Customer Complaint Notification — safety-relevant characteristic

Complaint no.	C-OEMN-2026-0312	Date issued	2026-09-22
Supplier	Componentes Arga S.L.	Supplier code	ARGA
Supplier part no.	AR-1003	OEM drawing no.	ON-114203 rev. D (fictitious)
Special characteristic	MIG weld strength (CC)	Quantity NOK (confirmed)	3
Supplier lot (label)	L26241-AR1003-02	Suspect qty delivered	788 pcs
Supplier delivery notes	AL-26-00542 — 394 pcs, shipped 2026-08-31 AL-26-00543 — 394 pcs, shipped 2026-09-04	Detected at	OEM Norte battery module assembly, in-line pull-out audit (station BM-2)
Part description	Battery tray bracket LH	Repeat indicator	YES — same supplier part no. and same characteristic within 24 months

Fig. 1 — Sample BM2-0921-A after pull-out, seam W2 (scale bar 10 mm). Crack from the end crater along the root.

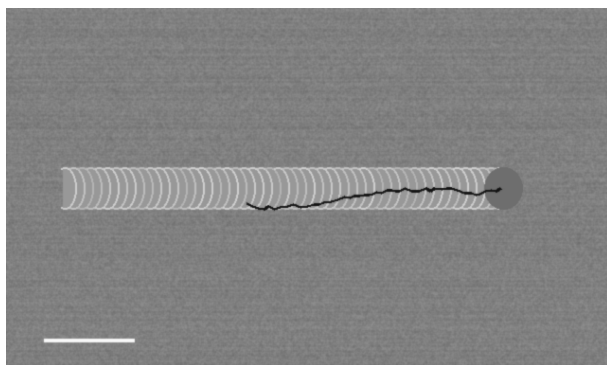
During the in-line pull-out audit of battery module assembly (1 part every 2 hours) on 2026-09-21, **3 battery tray brackets LH** broke at **MIG weld seam W2** below the minimum pull-out load (drawing note 7: ≥ 18 kN). The fracture starts at the end crater of W2 and runs along the weld root; the root side shows lack of fusion. The bracket carries the battery tray: characteristic classified CC (safety).

OEM Norte laboratory, macro-section of sample BM2-0921-B (report LAB-ON-26-4471): root penetration 0.4 mm (drawing: ≥ 1.0 mm), porosity and spatter inclusions near the end crater, irregular bead width along W2 (unstable arc suspected by our lab). Base material hardness and chemistry within specification.

1. **Containment within 24 h** (due 2026-09-23): block all suspect stock at the supplier and in transit, sort OEM Norte stock through your resident team or a third party, and confirm the suspect scope from your own traceability (production lots, material lots and delivery notes), not only from the lot on the label. Certified parts must carry a clean-point label.
